SERVICE No. 189 BULLETIN

Piper Aircraft Corporation

SUBJECT: Stabilator Tab Horn Modifications

MODELS AFFECTED: PA -23-250 Aztecs (Navy UO-1)
Serial Nos. 27-2 to 27-5 inclusive, 27-7 to 27-60
inclusive, 27-62 to 27-215 inclusive

SERVICE BULLETIN NO. 189

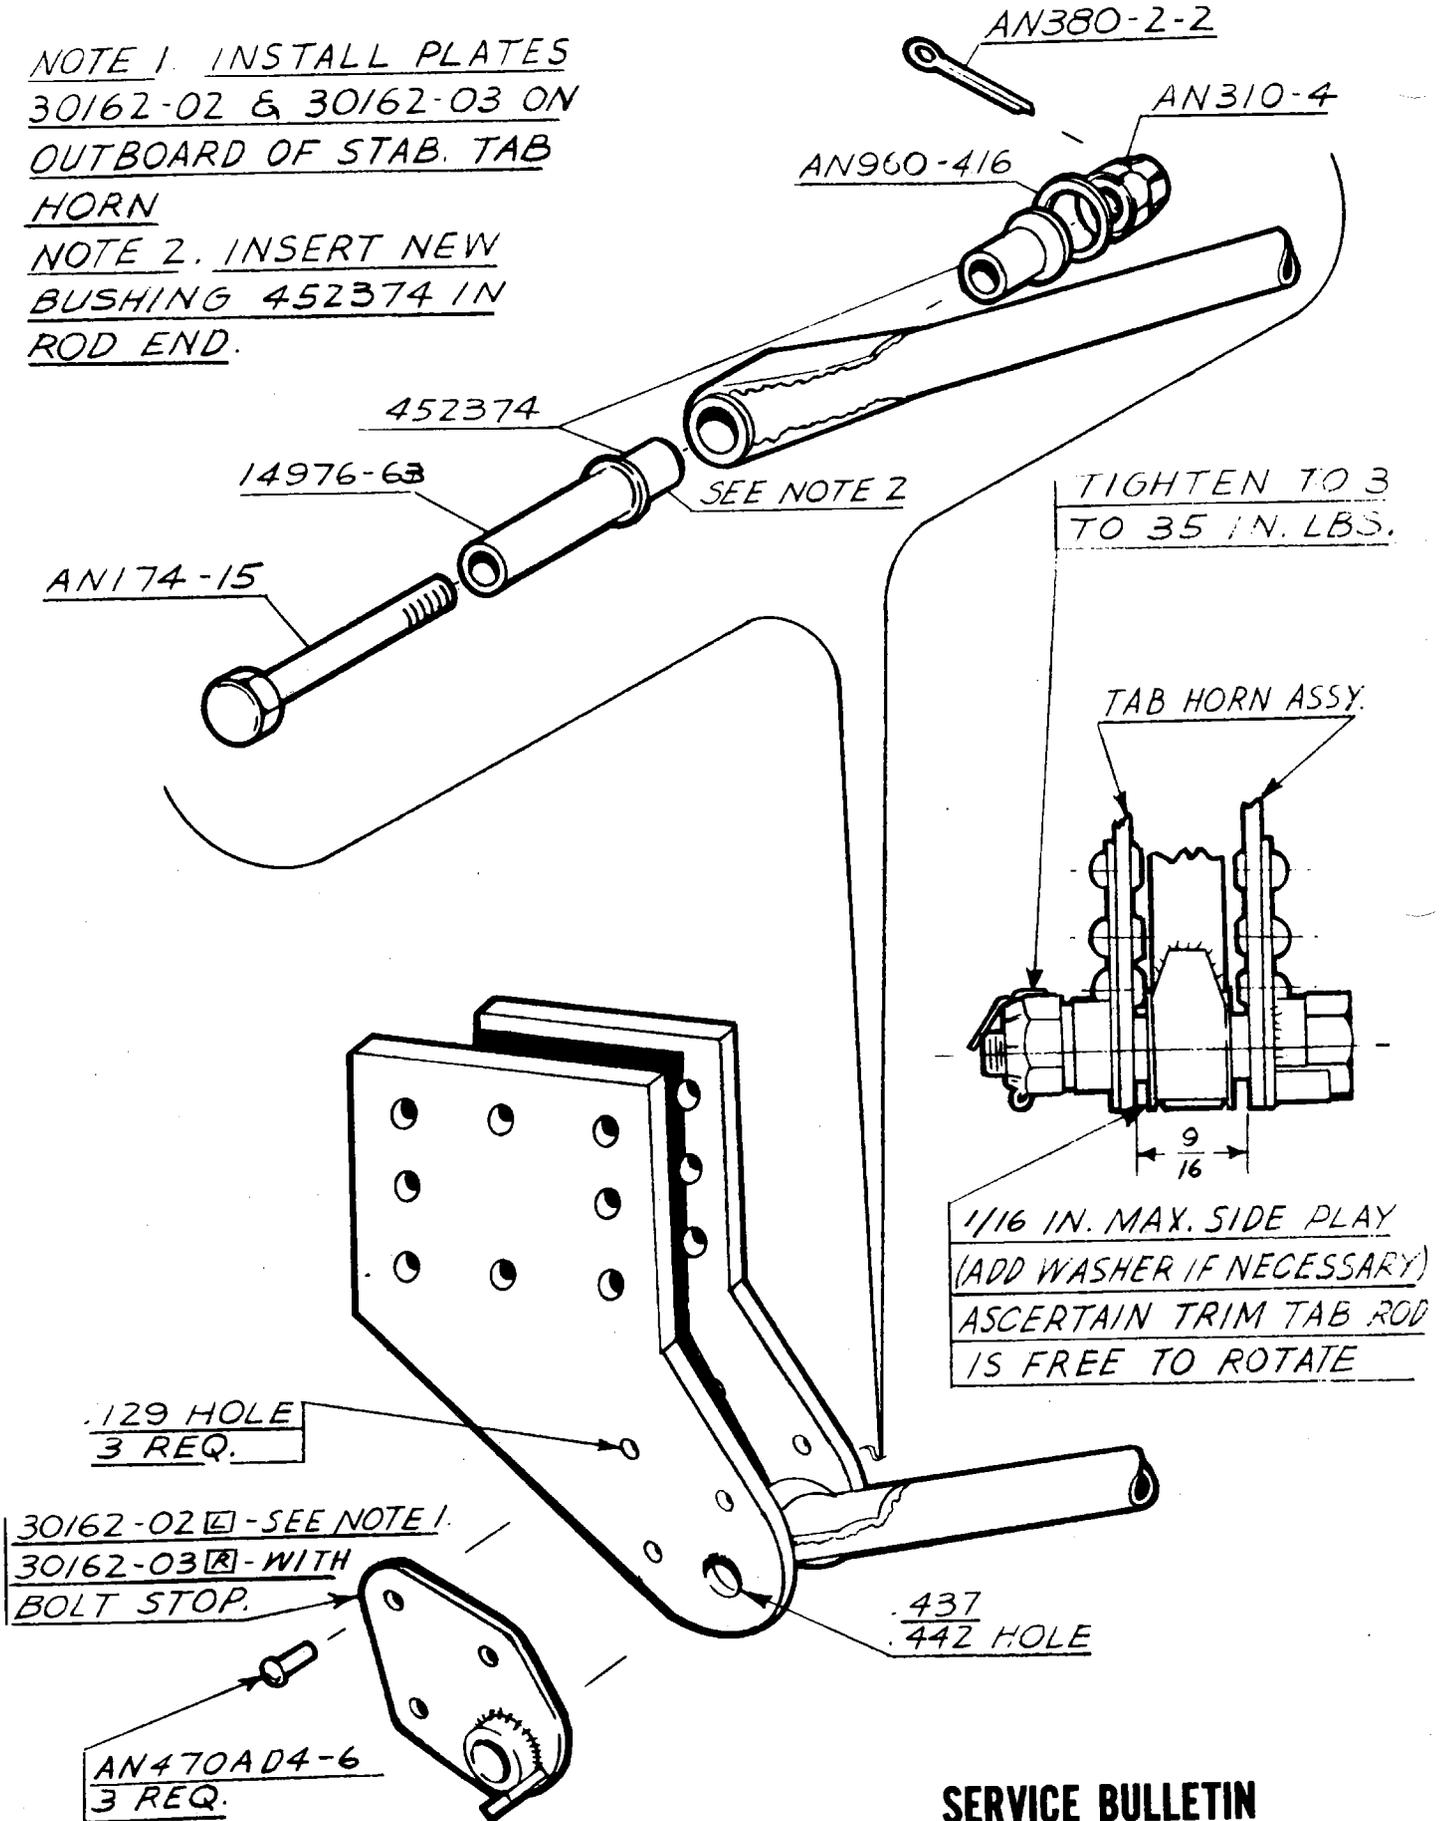
The Service Department has been advised that the stabilator tab horn actuating bolt has shown evidence of wear in service. The aircraft indicated by the above serial numbers should be modified as per the sketch on the reverse side of this bulletin.

NOTE 1. INSTALL PLATES 30162-02 & 30162-03 ON OUTBOARD OF STAB. TAB HORN

NOTE 2. INSERT NEW BUSHING 452374 IN ROD END.

TIGHTEN TO 3 TO 35 IN. LBS.

1/16 IN. MAX. SIDE PLAY (ADD WASHER IF NECESSARY) ASCERTAIN TRIM TAB ROD IS FREE TO ROTATE

.129 HOLE 3 REQ.

AN470AD4-6 3 REQ.

.437 .442 HOLE
